MONTICELLO NUCLEAR GENERATING PLANT
DOCKET NO. 50-263

LICENSE AMENDMENT REQUEST DATED AUGUST 4, 1975

PROPOSED CHANGES TO TECHNICAL SPECIFICATIONS
APPENDIX A OF PROVISIONAL OPERATING
LICENSE NO. DPR-22

Bases 3.11 (continued)

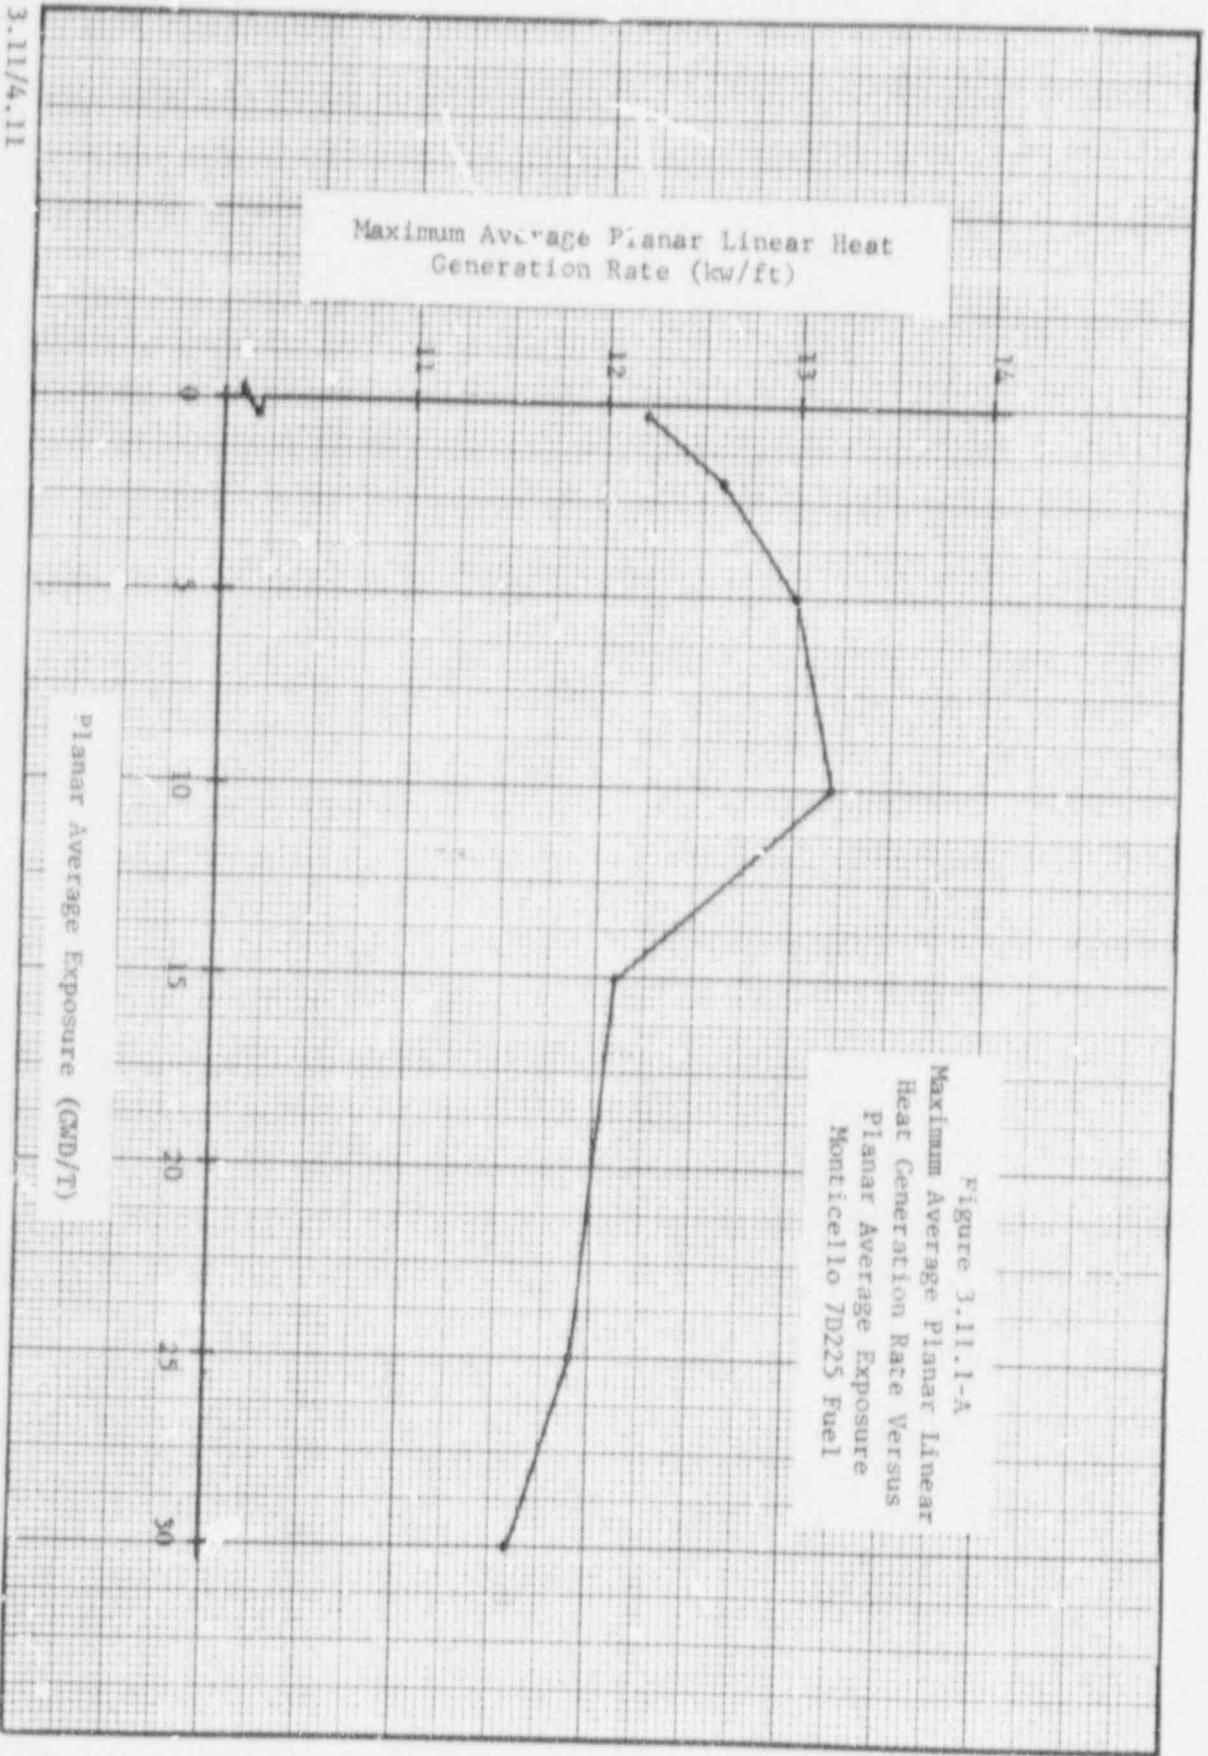
This page supersedes page 189F of Reference iv; it includes two minor changes. The second line of this page states that an initial operating MCPR using the ECCS calculations was 1.19. That value should be changed to 1.18. Reference 5 of page 189F should be changed as indicated in the attached Exhibit B.

Exhibit C uses an initial operating MCPR in the calculation which is slightly different than that used in Reference ii and reported in Reference iv. The assumed initial condition for the ECCS calculation is well below the operating limit discussed in the paragraph under change.

The change to Reference 5 on page 189F corrects an error in Reference iv.

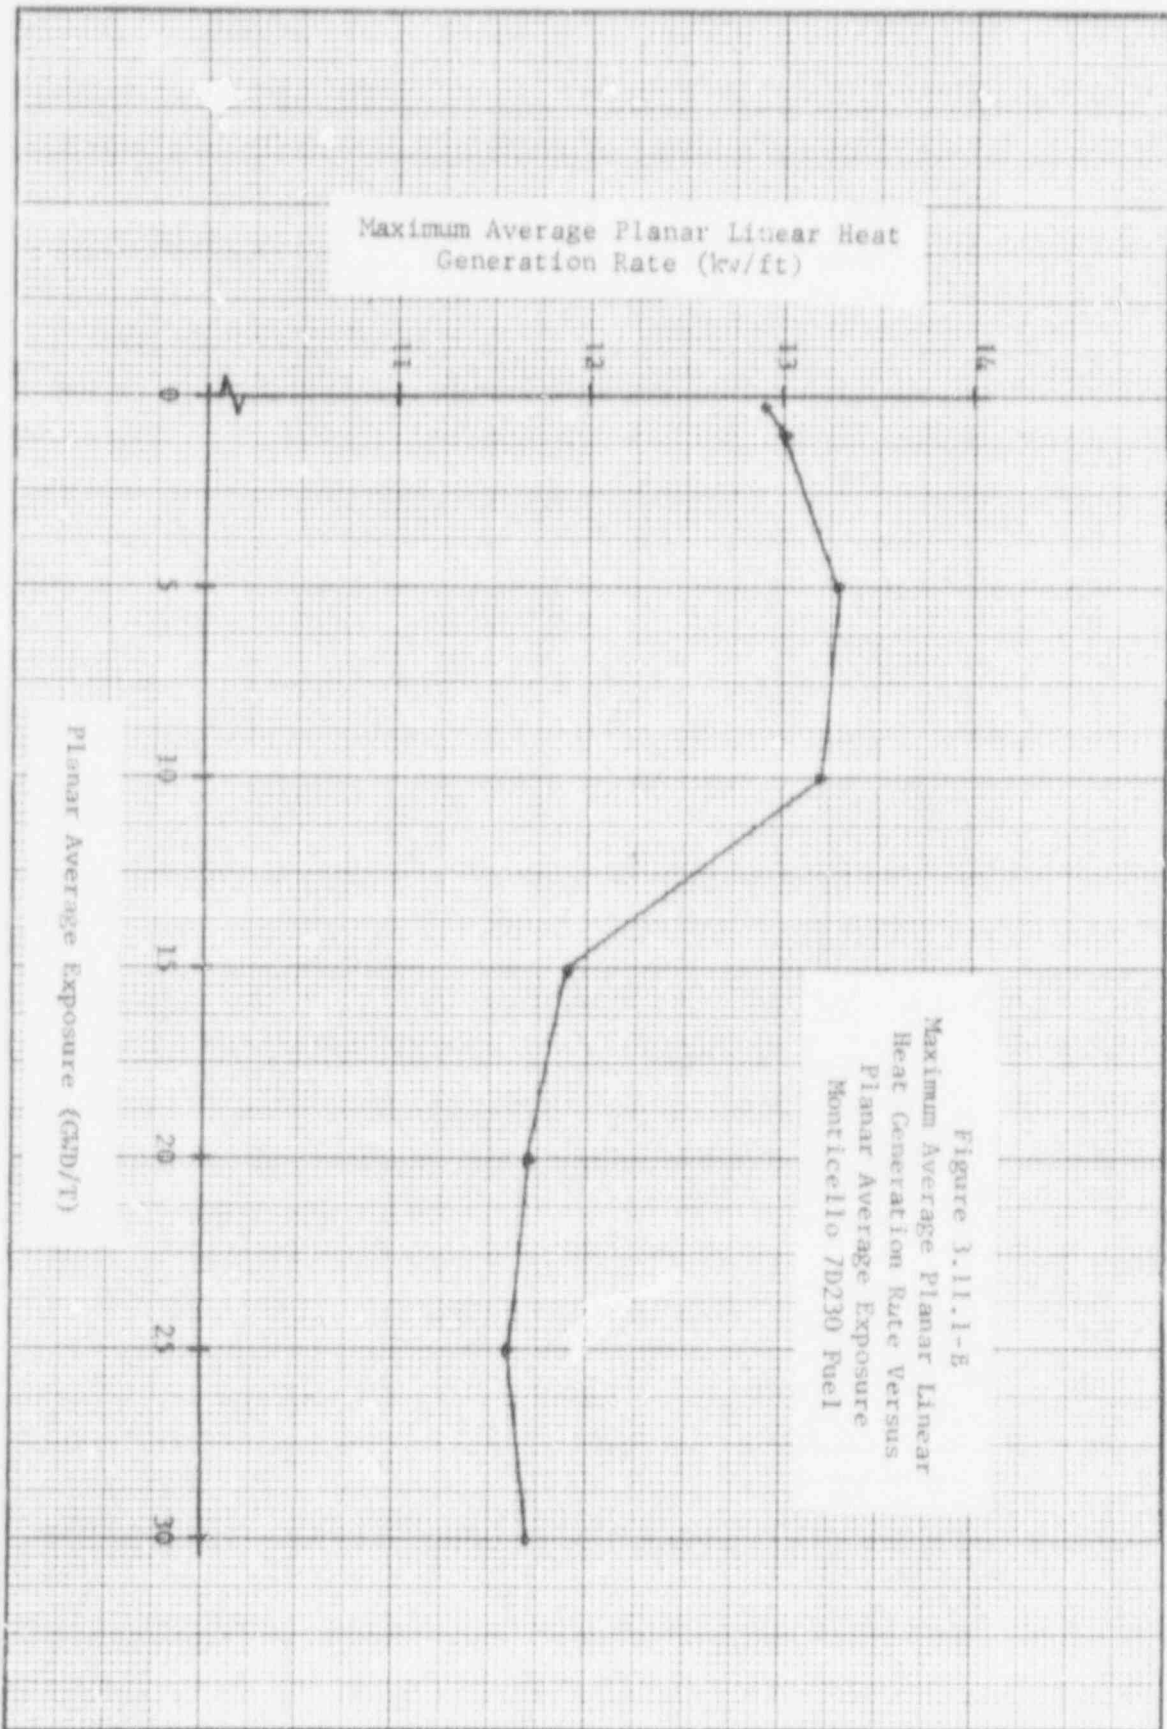
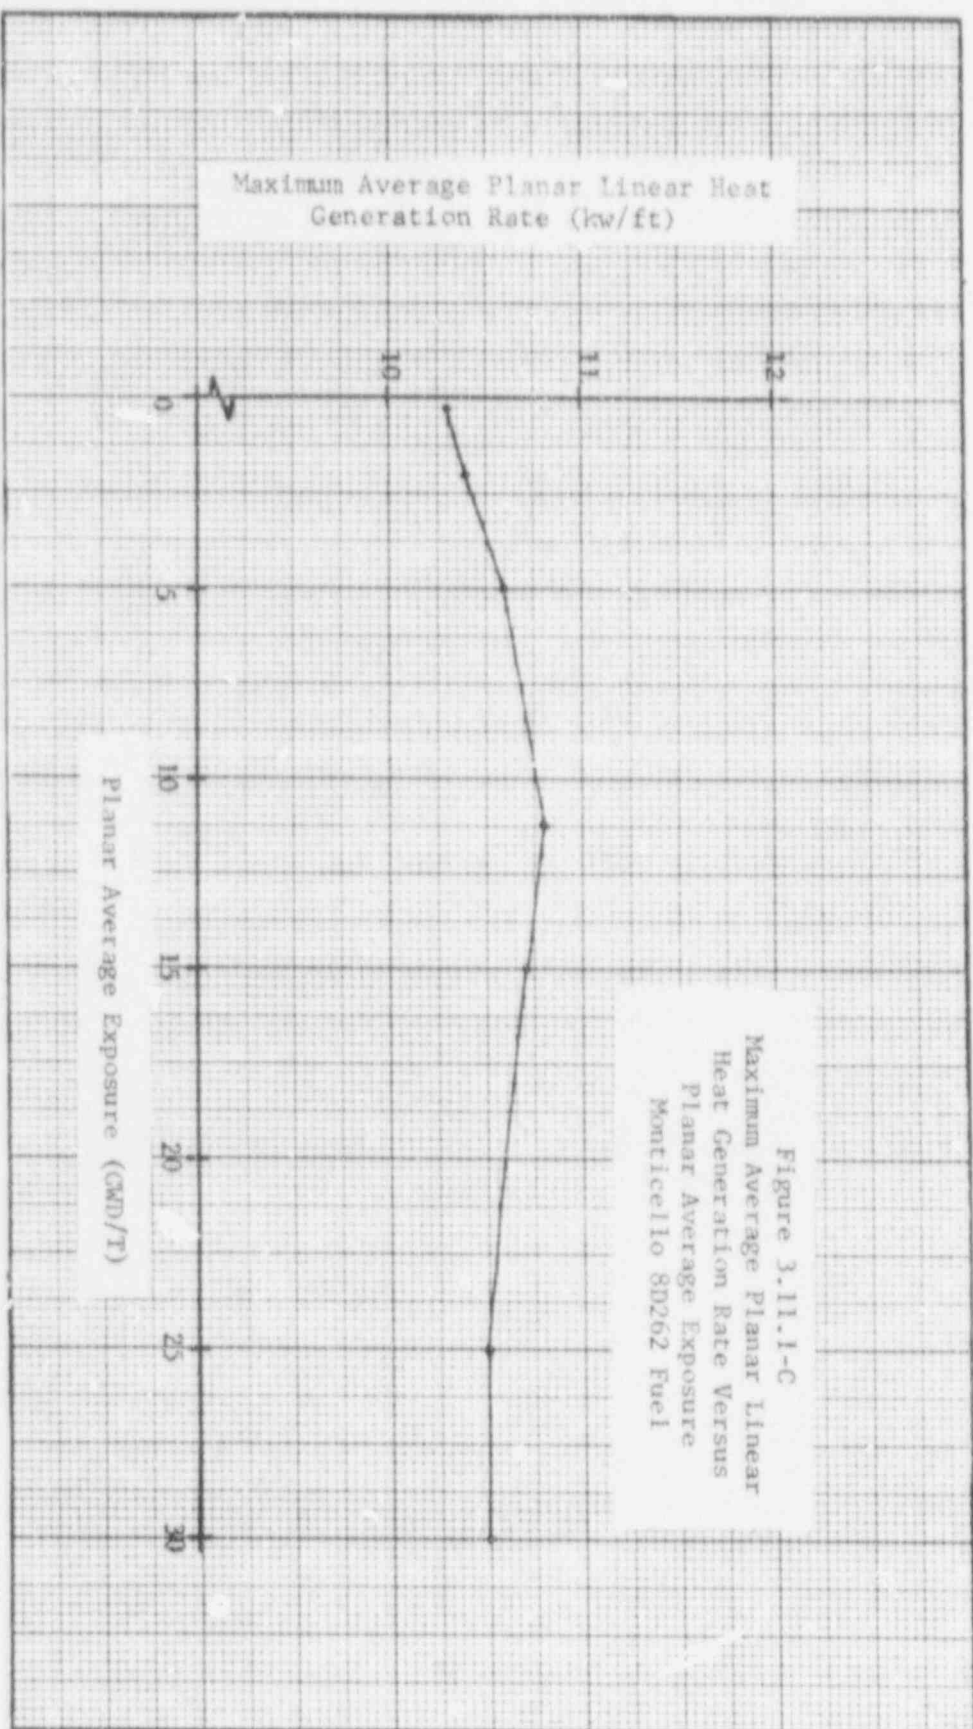
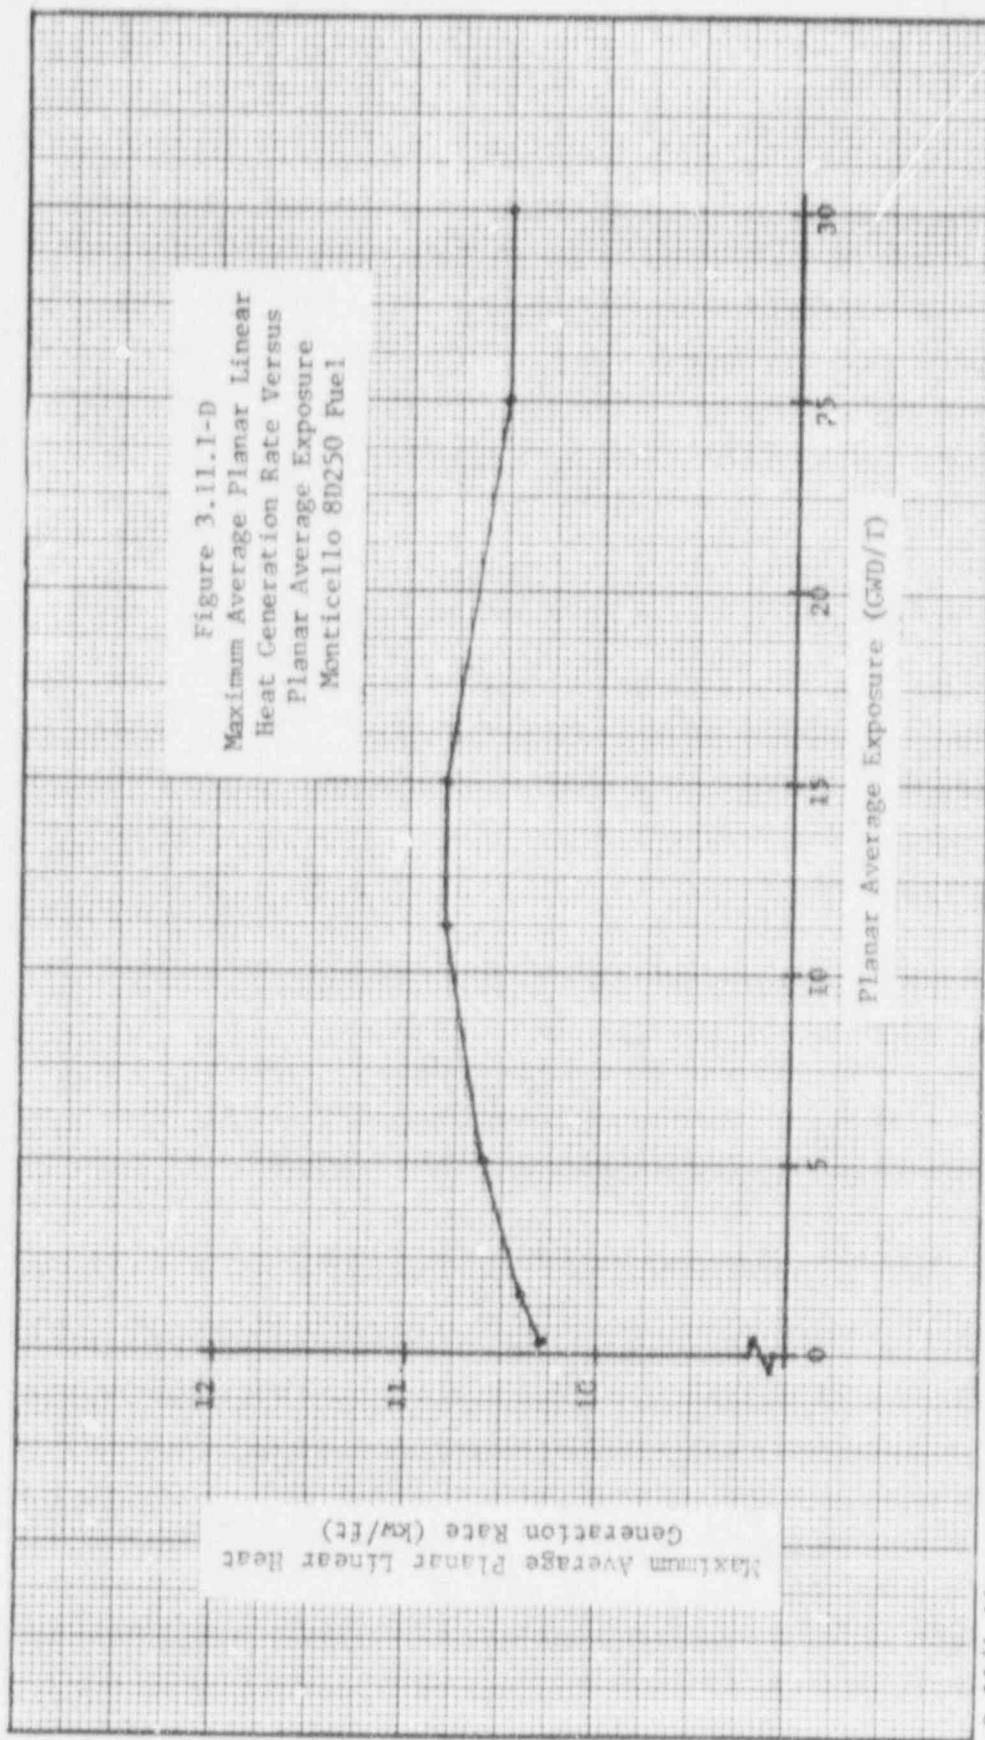
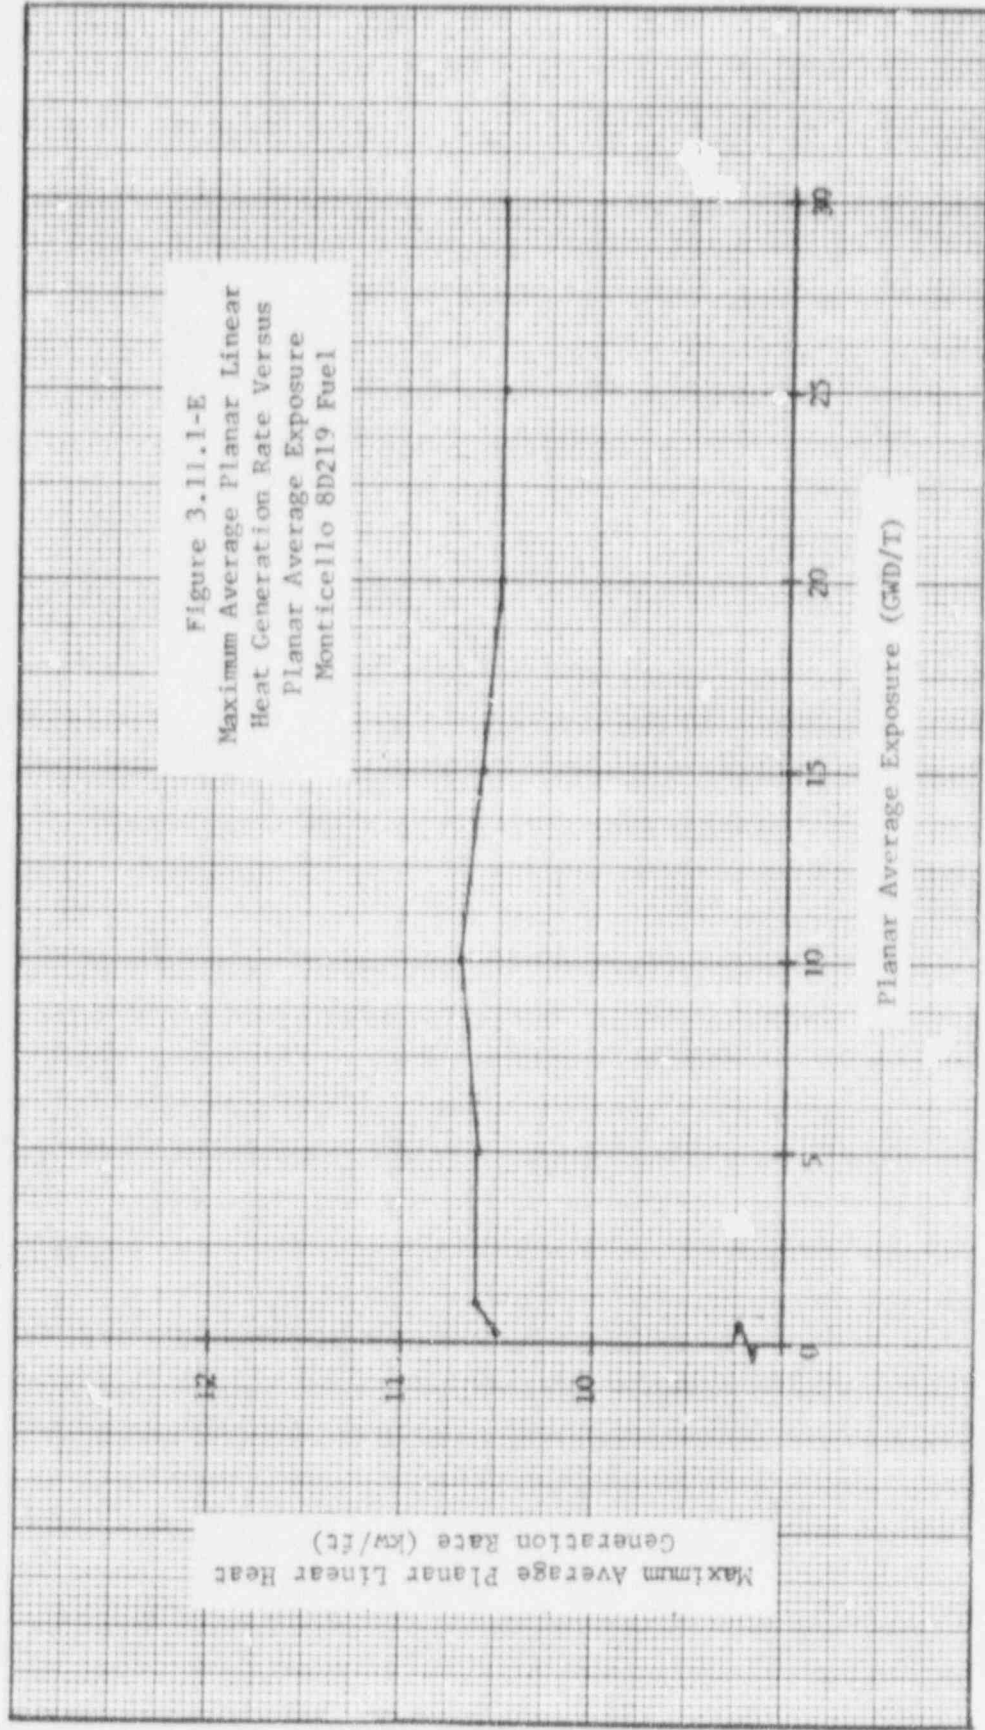
This specification currently exists as APLHGR limit figures in Reference i (page 108C), in the proposed changes in Reference ii (pages 189H, 189I, and 189J of Exhibit B) and in Reference iii (Figures A-1 through A-4). The attached APLHGR limit figures (pages 189H through 189L of attached Exhibit B) are proposed to replace the limits stated in each of the three above references. The remaining portions of Reference ii are not affected.

NOTE: Three fuel types are considered in References i and ii. The fourth fuel type currently in use at Monticello was not limited by ECCS considerations using the model described in Reference ii. Because of changes in the ECCS model required by the AEC staff, Reference iii imposed a restriction on this fourth fuel type also. The proposed changes shown in the attached Exhibit B include APLHGR limits for the four fuel types currently in use at Monticello as well as a fifth type soon to be loaded in the Monticello reactor.

These proposed changes are provided in accordance with the requirements of Reference iii. They are the result of calculations using an ECCS model modified to incorporate the changes required by that reference. The attached Exhibit C discusses the revised ECCS model and presents the results.
